REQUEST FOR PROPOSALS No. 26-034

GNPCC Grit & Sedimentation Tanks 2027 Refit Work

Addendum 1

Addendum 1a

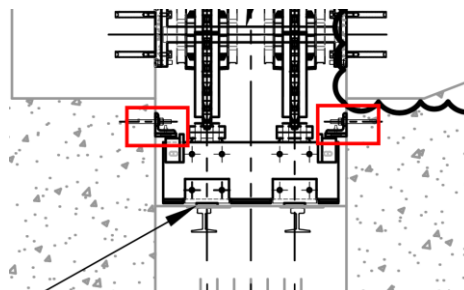
2. **Question:** For the plate found in the bottom of the Grit Tank 1 trench, please describe the installation method to better understand removal.

Answer: Please note there was a typo in the RFP, and there is no scope of work in this RFP for Grit Tank 2. As observed in the Brentwood drawing package, the trench is approximately 2' wide, and 28' long (not including the sump). Please make the following assumptions with regards to the existing construction:

- It was installed in 5 separate sections (5' to 6' each)
- The sheet is carbon steel, and 1/8" thickness
- The sheets were drilled thru, then carbon steel inserts installed
- Bolts were then installed, then plug welded and grinded flush w/ top of plate
- Assume 4x bolts per plate, which would be a total of 20.

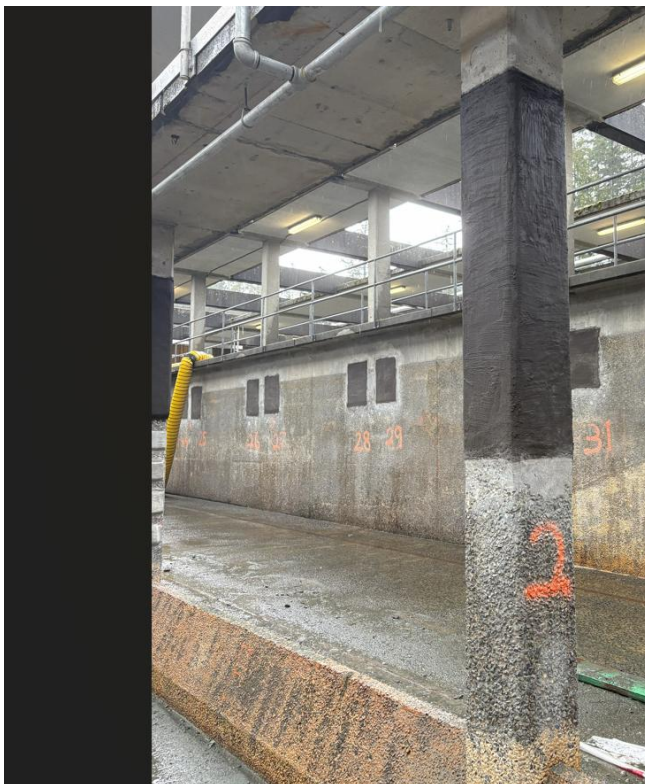
5. **Question:** What allowance should be given for the longitudinal rails requiring grinding in Sed Tank 1?

Answer: *Please assume there will be 10 locations that will require grinding in the tank, with an area of 2"x6", and a ¼" of thickness requiring grinding. In the past we have had success grinding these rails with an aluminum oxide wheel.*
